**Proposal for amendments to
ECE/TRANS/WP.29/GRPE/2023/03
UN Regulation No. [XXX] on uniform provisions
concerning the approval of light duty passenger and
commercial vehicles with regards to real driving
emissions (RDE)**

This document proposes some amendments to the above paper which OICA members request to be integrated at first adoption of the new Regulation. The modifications to the current text of the Regulation are marked in bold for new or strikethrough for deleted characters.

"Annex 3

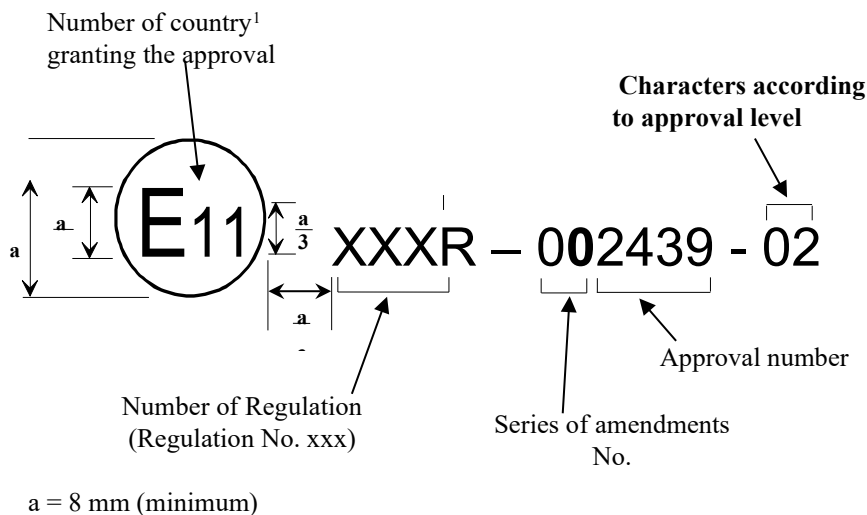
Annex 3, amend to read:

In the approval mark issued and affixed to a vehicle in conformity with paragraph 5. of this Regulation, the type approval number shall be accompanied by an alphanumeric character reflecting the level that the approval is limited to.
